SERVICE BULLETIN

M-1238

December 18, 2008

2009 DYNA JIFFY STAND SPRING ANCHOR SAFETY RECALL 0137

Figure 1. Jiffy Stand Assembly

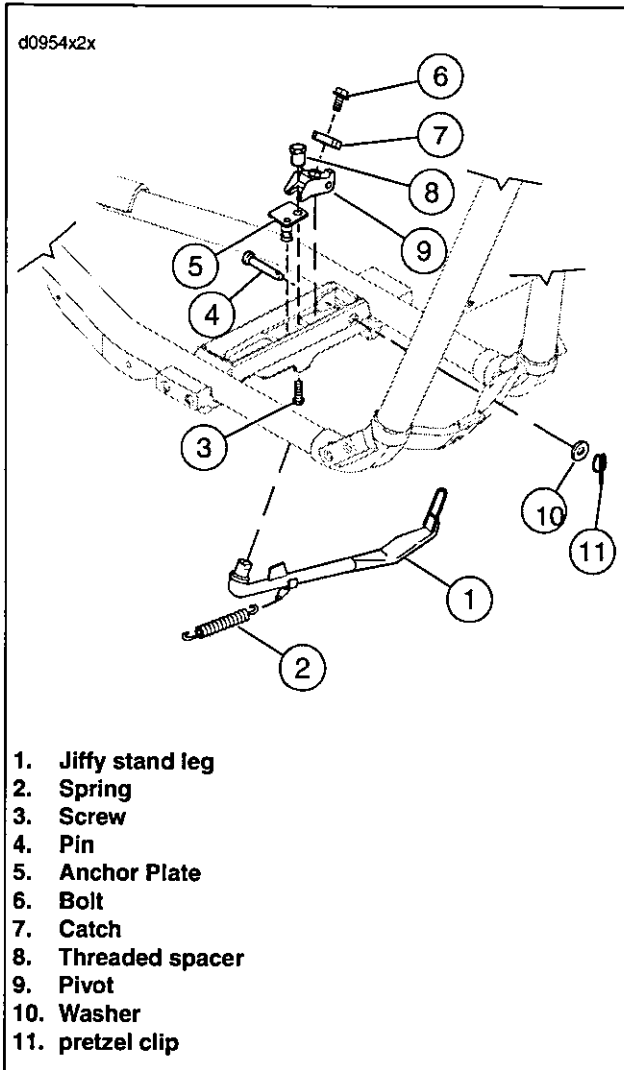
Harley-Davidson has determined that a condition affecting motor vehicle safety exists on certain 2009 model year Dyna FXD, FXDF, FXDC, FXDL, FXDB vehicles. These motorcycles have a jiffy stand Spring Anchor Part No. 47318-98, that may have been made with a defective weld that may allow the jiffy stand assembly to not retract as intended. This condition could lead to an accident which could cause injury or death to the rider.

See Figure 1. Do not disassemble jiffy stand assembly once removed from chassis.

3. Remove the anchor plate (5) from frame.
4. Install **new** anchor plate from the recall kit.
5. Install jiffy stand assembly using **new** screw (3) provided in kit. See Chapter 2 of the 2009 DYNA Models Service Manual.
